## **ADDENDUM – 3**

September 10, 2024

### **PAWTUCKET HOUSING AUTHORITY Galego Court Security Camera Improvements**

**PAWTUCKET-PROVIDENCE COUNTY-RHODE ISLAND  
 PAWTUCKET HOUSING AUTHORITY  
 SECURITY CAMERA IMPROVEMENTS  
 GALEGO COURT  
 EXISTING CONDITIONS**

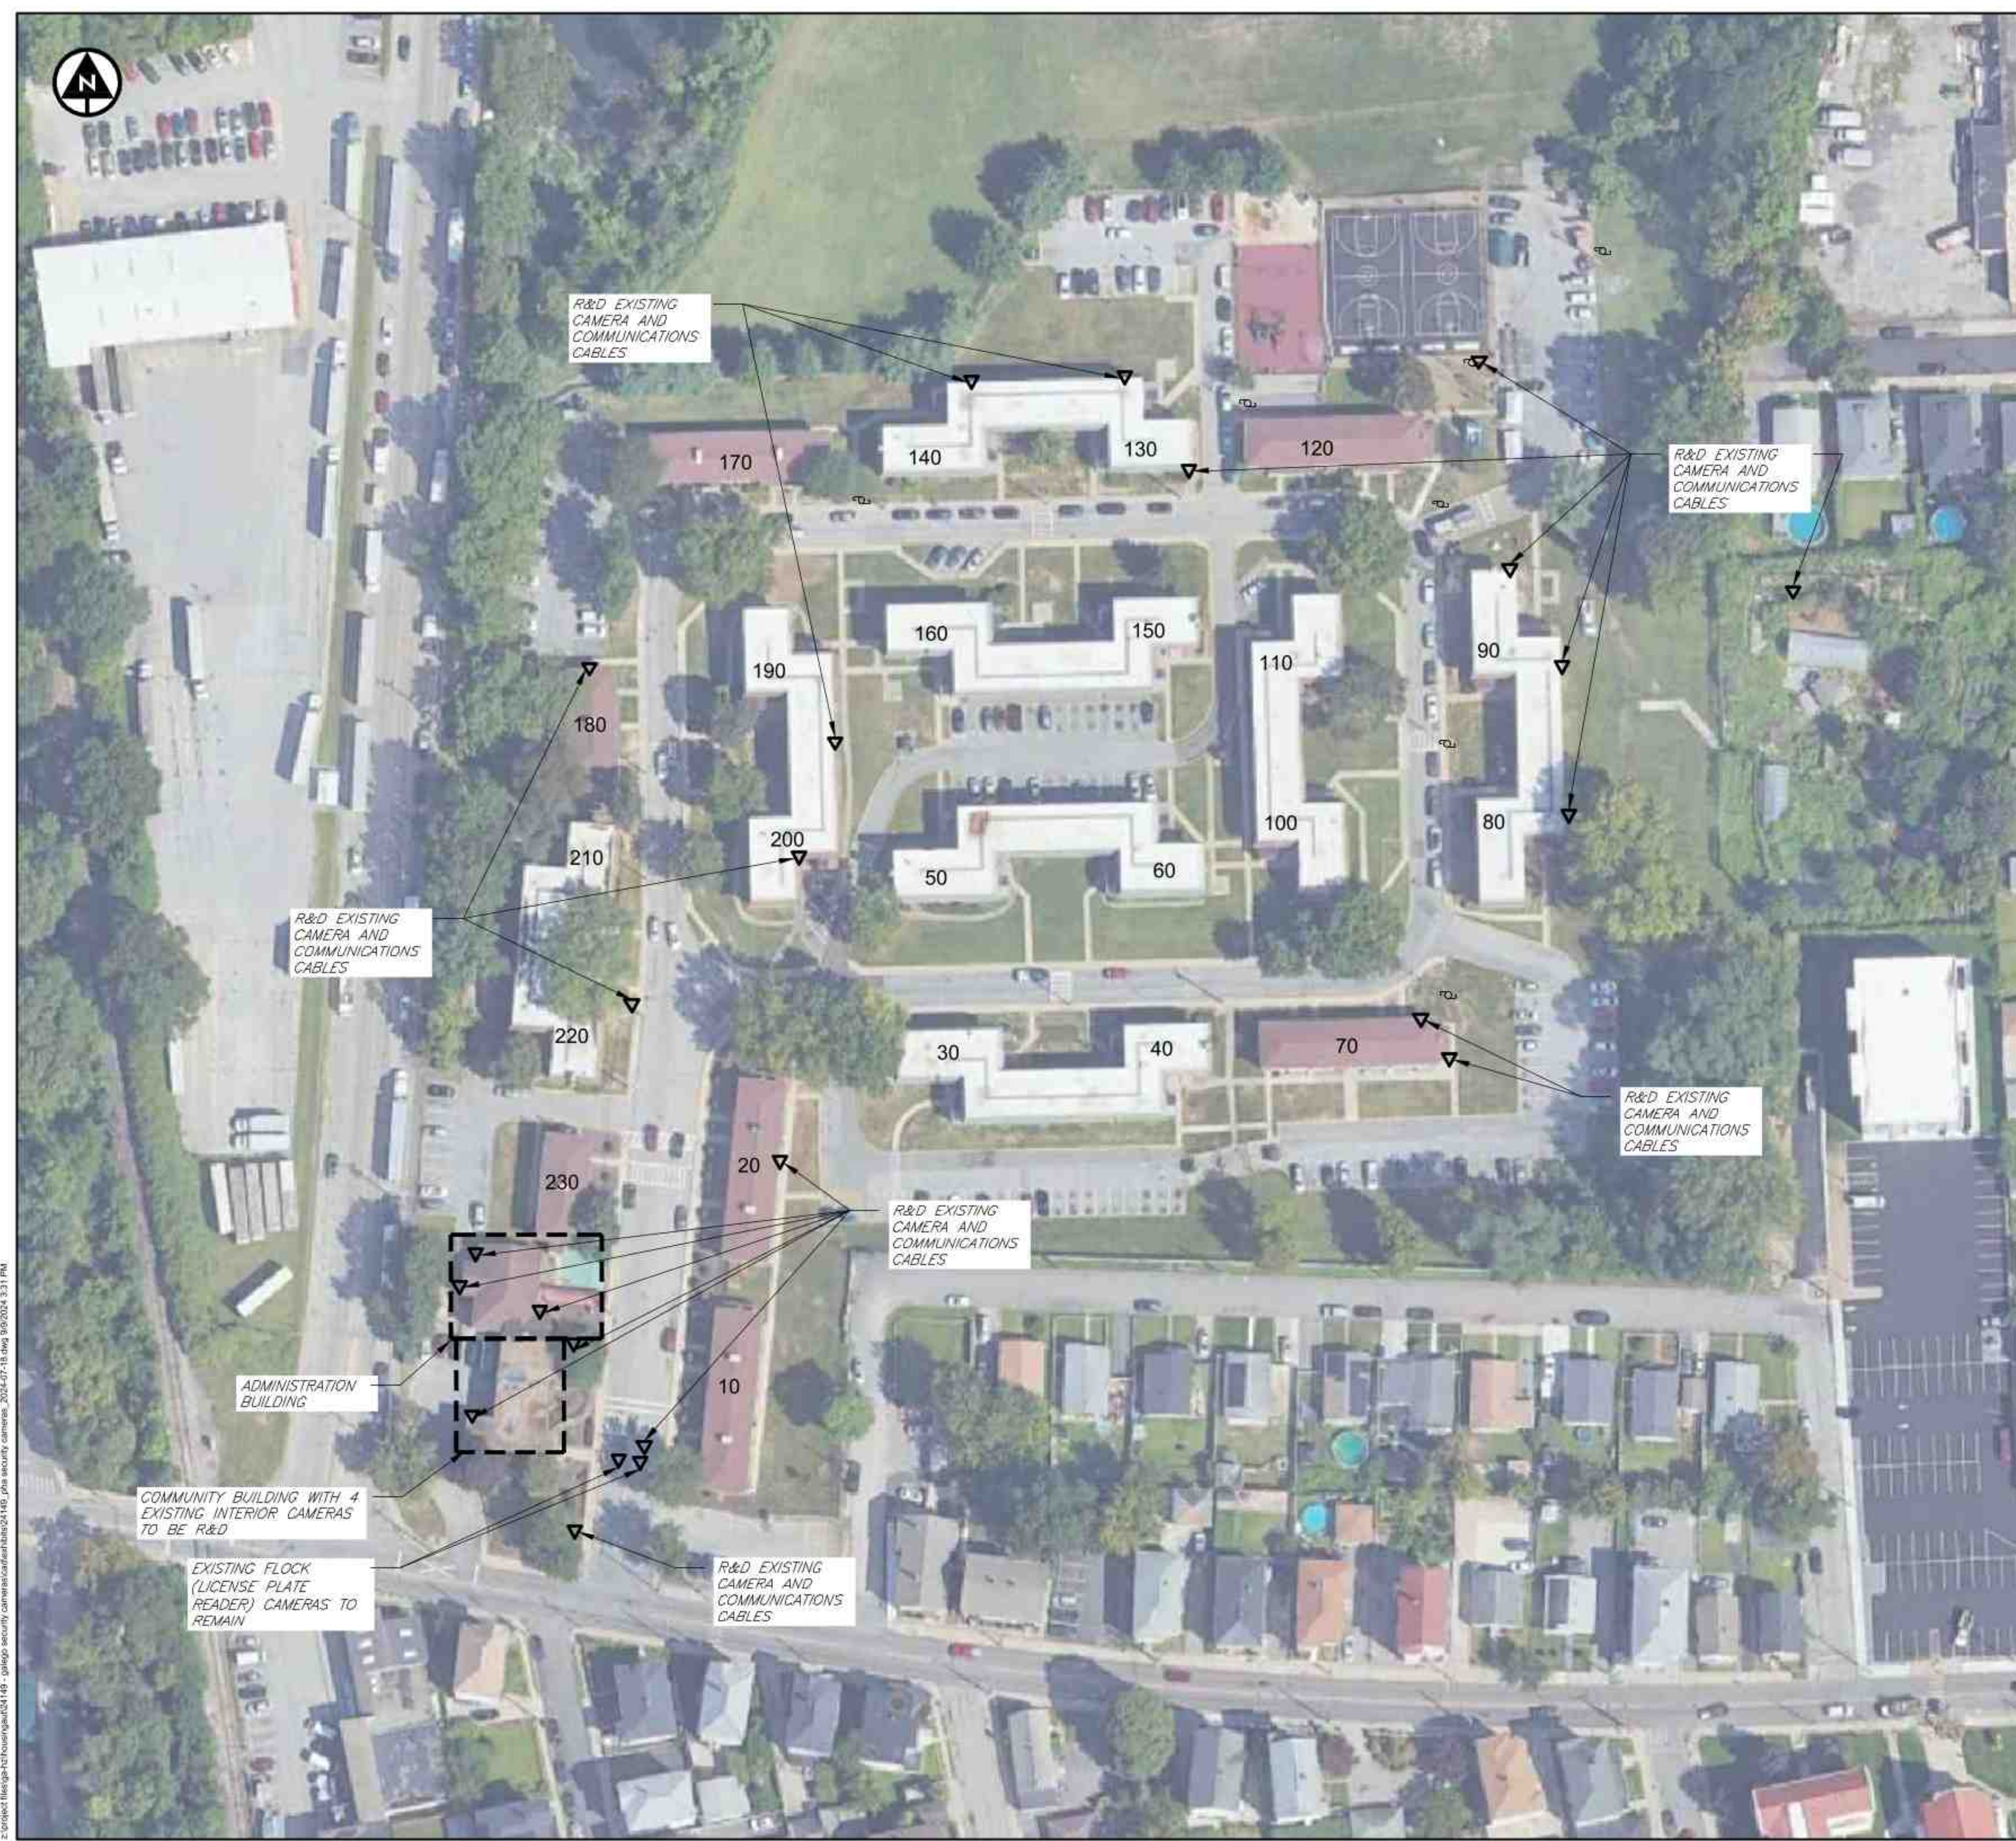
- Item 1: Add alternate Bid Item 3. Aerial Fiber Installation has been added to the bid proposal, summary of work, and measurements and payments. This item has been added to provide an alternate method of installation in lieu of Add Alternate 1. Trench Grassed Areas and Add Alternate Item 2. Trench Asphalt Area.

1. CONTRACTOR SHALL TRENCH NEW CONDUIT UNDER GRASSED AREAS AND CONCRETE AS NEEDED AND REPAIR DISTURBED AREAS TO ORIGINAL CONDITION.
2. CONTRACTOR SHALL SAWCUT AND TRENCH NEW CONDUIT UNDER ASPHALT PAVEMENT AS NEEDED AND REPAIR DISTURBED AREAS TO ORIGINAL CONDITION.
3. CONTRACTOR SHALL INSTALL AERIAL FIBER BETWEEN BUILDINGS AND UTILITY POLES FOR CAMERA SYSTEM OPERATION.
